Well Name: BIG EDDY UNIT 30E REY	Well Location: T20S / R31E / SEC 14 / SWSW / 32.56953 / -103.84714	County or Parish/State: EDDY / NM
Well Number: 103H	Type of Well: OIL WELL	Allottee or Tribe Name:
Lease Number: NMLC063667	Unit or CA Name: BIG EDDY	Unit or CA Number: NMNM68294X
US Well Number: 3001548156	Operator: XTO PERMIAN OPERATING LLC

Notice of Intent

Sundry ID: 2390606

Procedure Description: **SHL Change, Spacing, Casing/Cement, Drilling Variance Changes XTO Permian Operating, LLC requests permission to make the following changes to the original APD: No Additional Surface Disturbance Change SHL fr/1265'FSL & 405'FWL to 1065'FSL & 590'FWL Total SHL Move: 200'South & 185'West SHL change requested to optimize drill island space and for safety purposes. Change BHL fr/20'FSL & 50'FEL to 1540'FNL & 50'FEL Casing/Cement design per the attached drilling program. XTO also requests the following variances: Approval to utilize a spudder rig to pre-set surface casing per the attached description of operations. Batch drill this well if necessary. In doing so, XTO will set each casing string and ensure that the well is cemented properly and the well is static. With floats holding, no p

DRAWN	DLE	18JAN21
APPRV		
DRAWING NO. HBE0000479

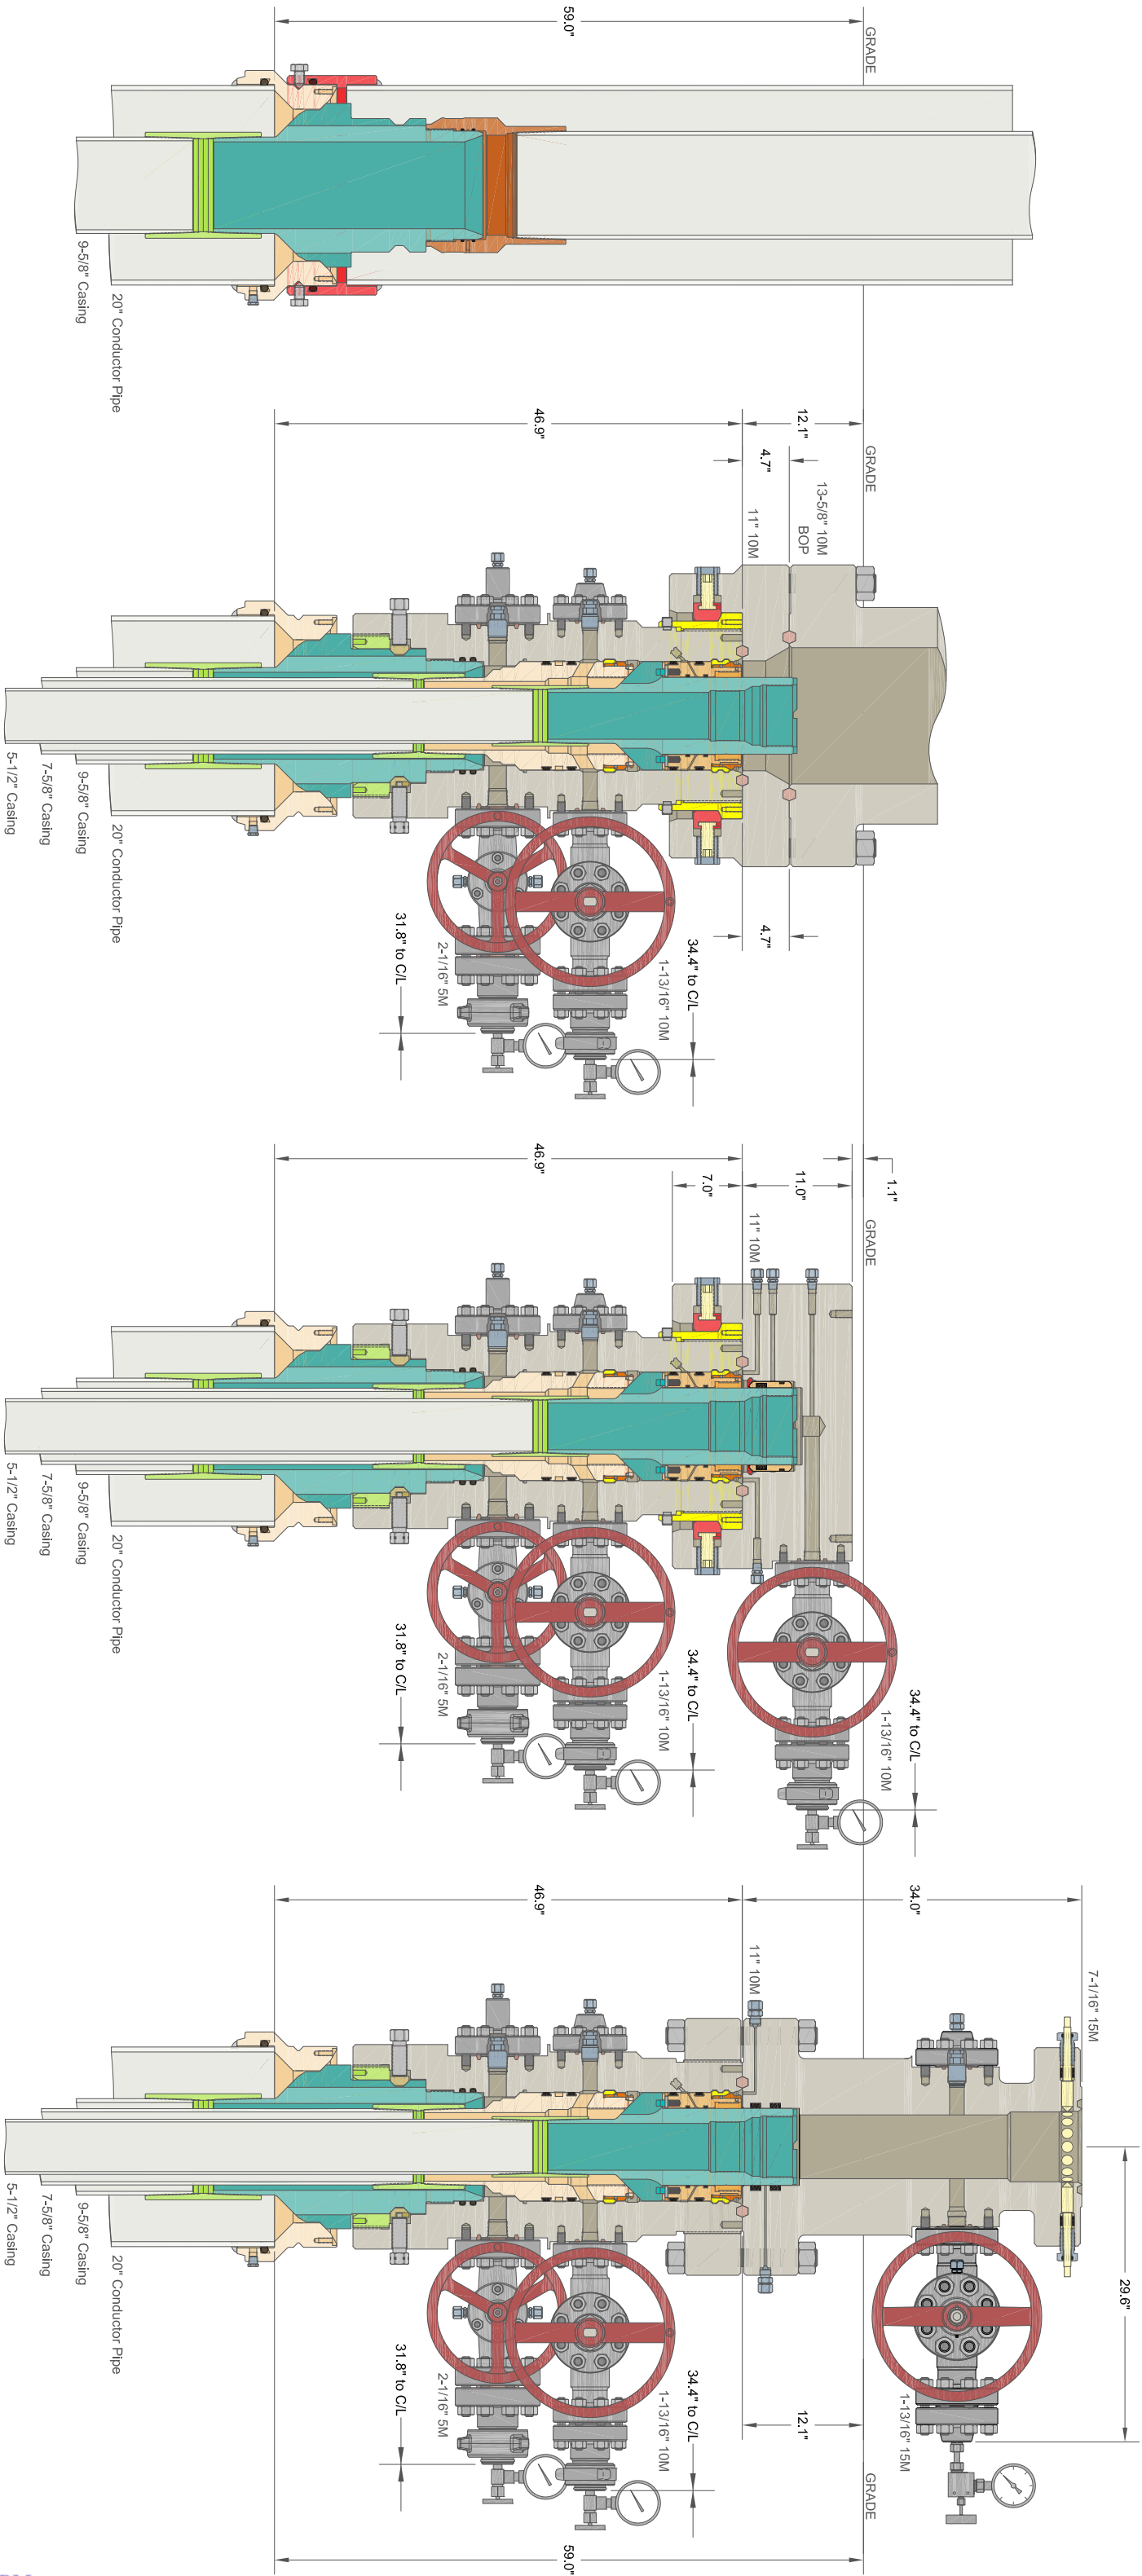
- Wellhead will be installed by manufacturer's representatives.
- Manufacturer will monitor welding process to ensure appropriate temperature of seal.
- Operator will test the 7-5/8" casing per BLM Onshore Order 2
- Wellhead Manufacturer representative will not be present for BOP test plug installation

5M Choke Manifold Diagram

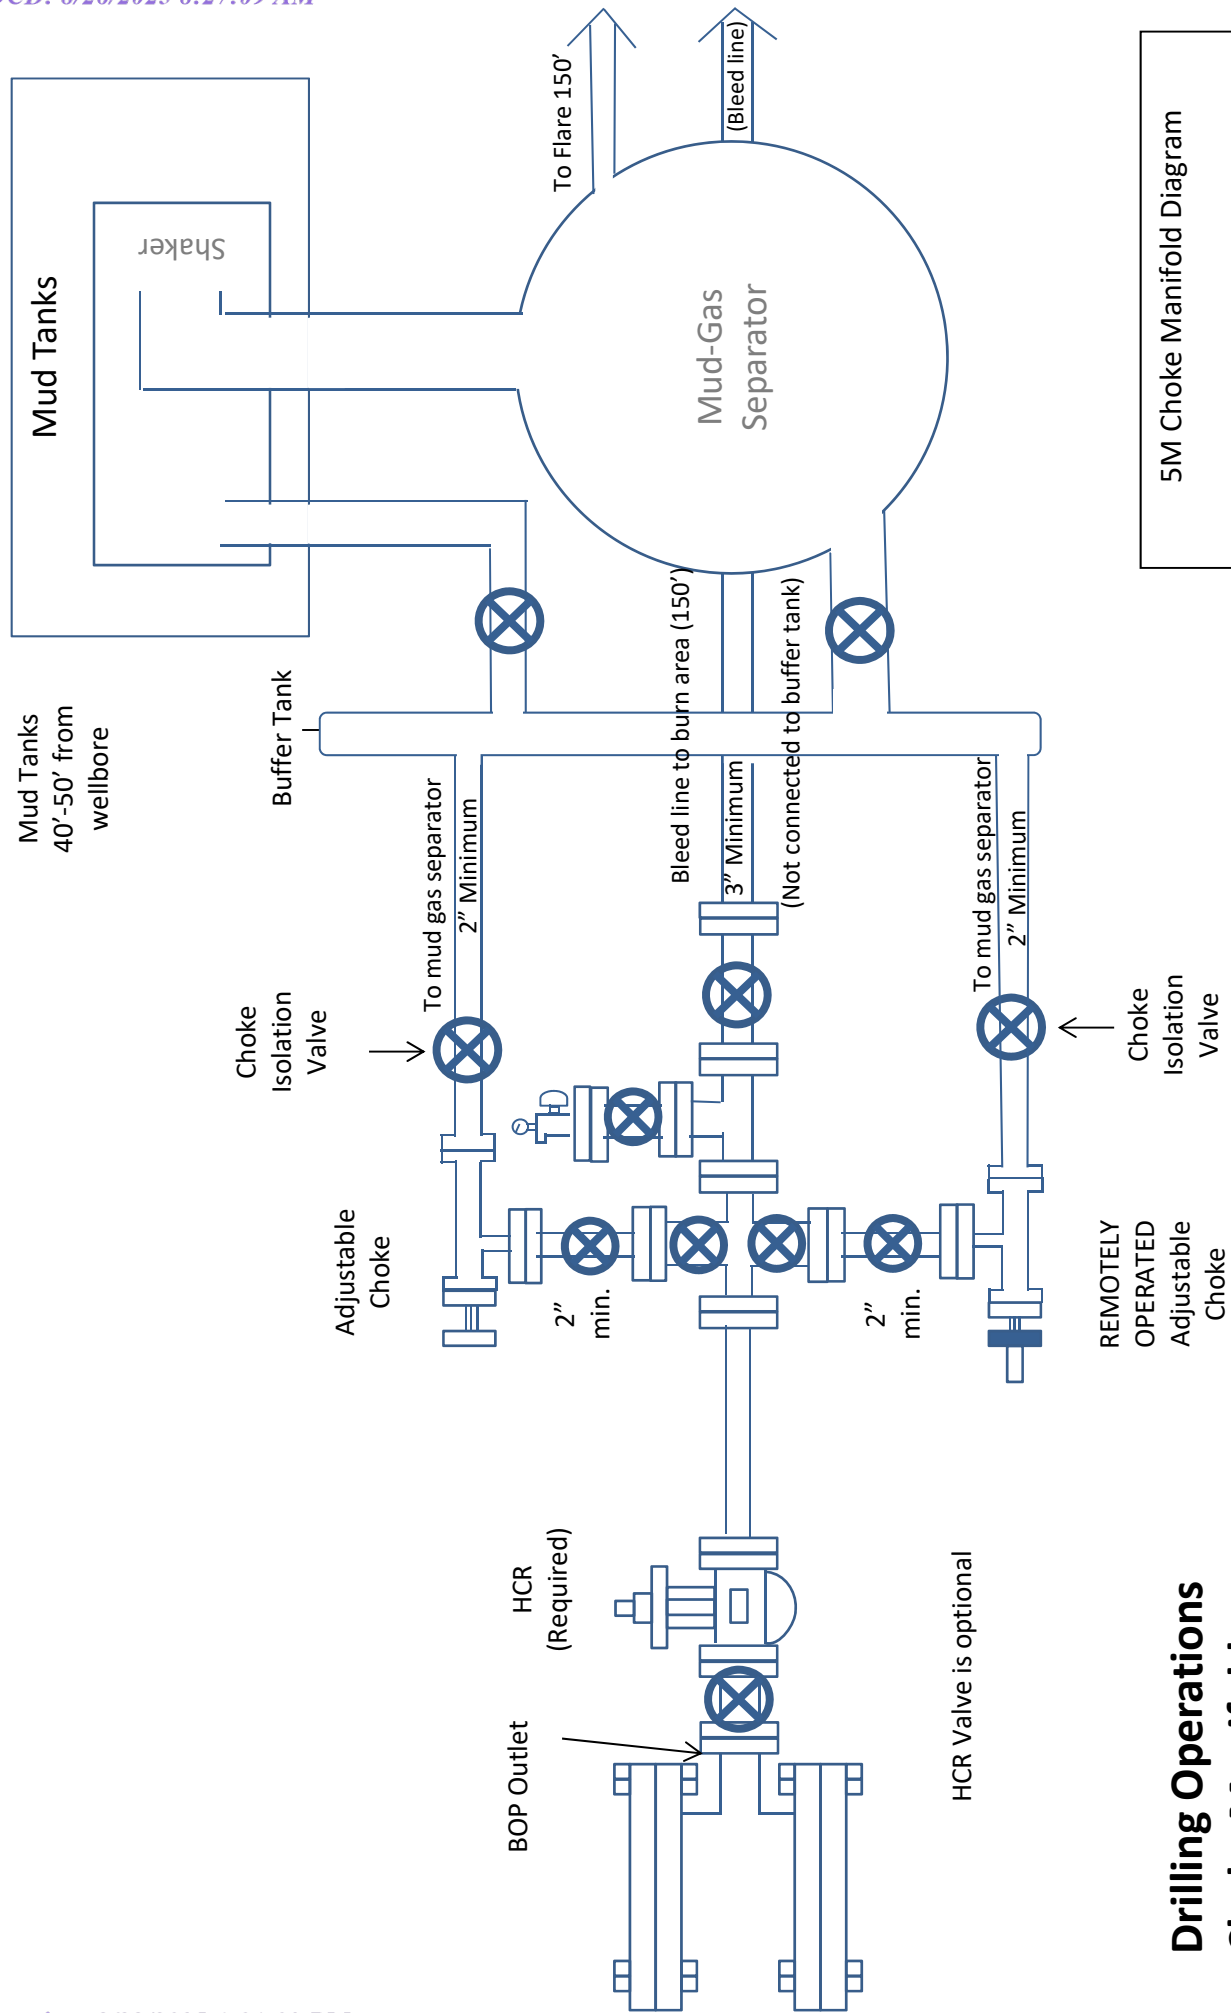
A variance is requested to allow use of a flex hose as the choke line from the BOP to the Choke Manifold. If this hose is used, a copy of the manufacturer's certification and pressure test chart will be kept on the rig. Attached is an example of a certification and pressure test chart. The manufacturer does not require anchors.

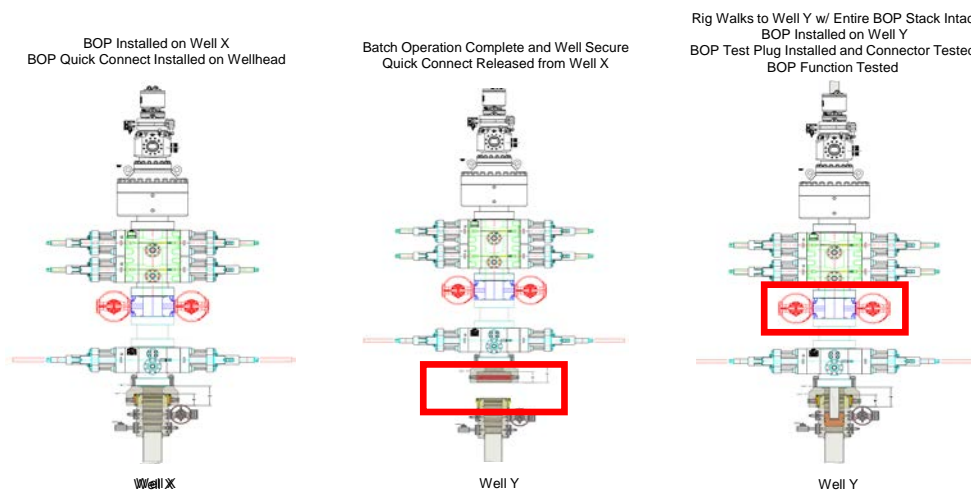
Note: Picture below highlights BOP components that will be tested during batch operations

All valves in red including the upper pipe rams will be shut to test the broken connections.

** Each valve on choke manifold will alternate being tested against during each rig skid.

The connection between the HCV and kill line connection will **NOT** be broken on each skid and does not need to be retested.

The connection between the BOP stack / BOP Quick Connect and wellhead will be broken, as well as, the connection between the HCV and Choke Line on each skid and will be re-tested each time.

BOP Break Testing Variance (Note: Shell testing is not approved for any portion of the hole with a MASP of 5000 psi or greater)

- While in transfer between wells, the BOPE shall be secured by the hydraulic carrier or cradle.
- Any well control event while drilling require notification to the BLM Petroleum Engineer prior to the commencement of any BOP Break Testing operations.

A full BOP test is required prior to drilling the first deep intermediate hole section. If any subsequent hole interval is deeper than the first, a full BOP test will be required.
